IN THE UNITED STATES PATENT AND TRADEMARK OFFICE

Serial No. 10/004,511

For: METHOD AND APPARATUS  
FOR JEWELRY ORGANIZATION

AMENDMENT

FIG. 4

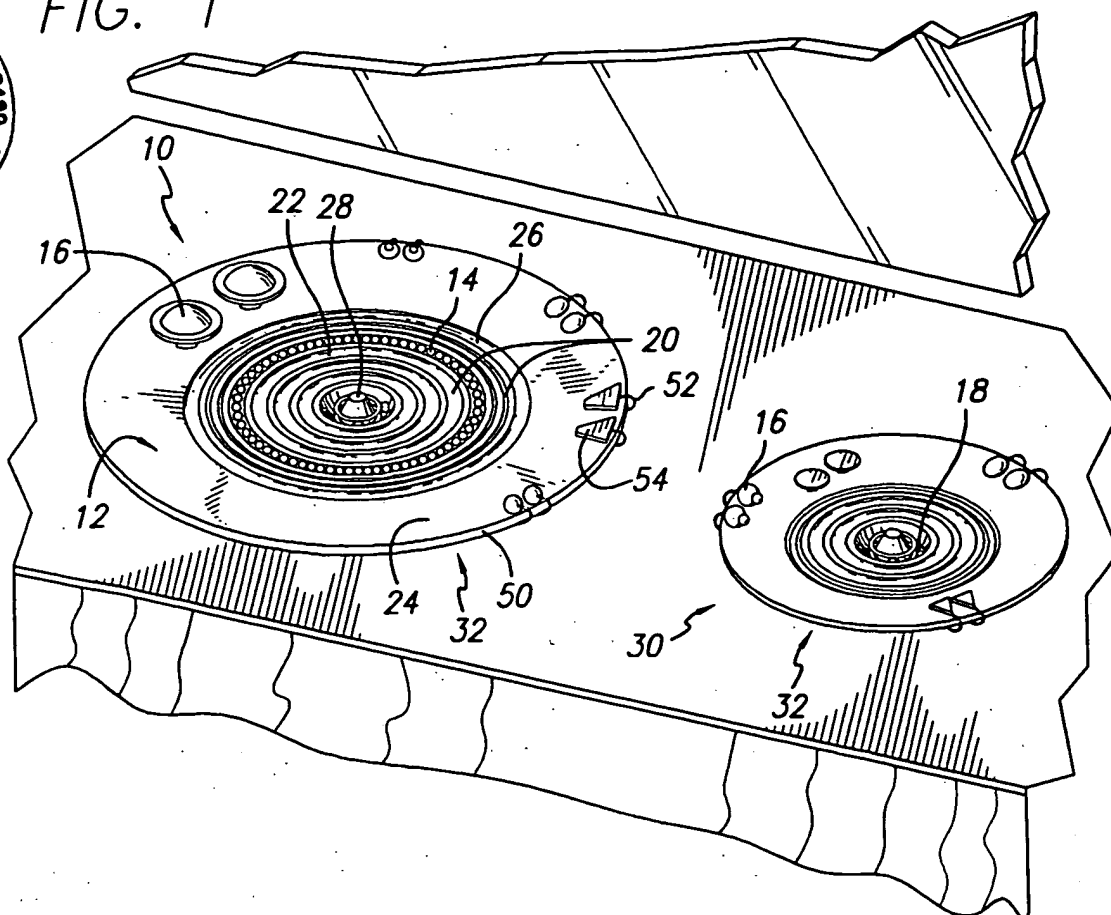
The attached sheets of drawings include changes to FIGS. 3 and 4 and deletion of FIG. 5. These sheets, which include FIGS. 1-4, replace the original sheets including FIGS. 1-4 and the sheet including FIG. 5 that was added by *Amendment* dated August 30, 2002.

Applicant also proposes to correct certain reference numeral errors in the Figures 3 and 4 of the drawings to better conform to the specification. Specifically, in Figure 3 Applicant has deleted one numeral 38 as inconsistent with the specification, extended the lead line on numeral 32 to make clear that it refers to the lower surface of the body, and added numerals 46 and 48. In Figure 4, Applicant has deleted numerals 30 and 32. No new matter has been introduced by these drawing corrections.
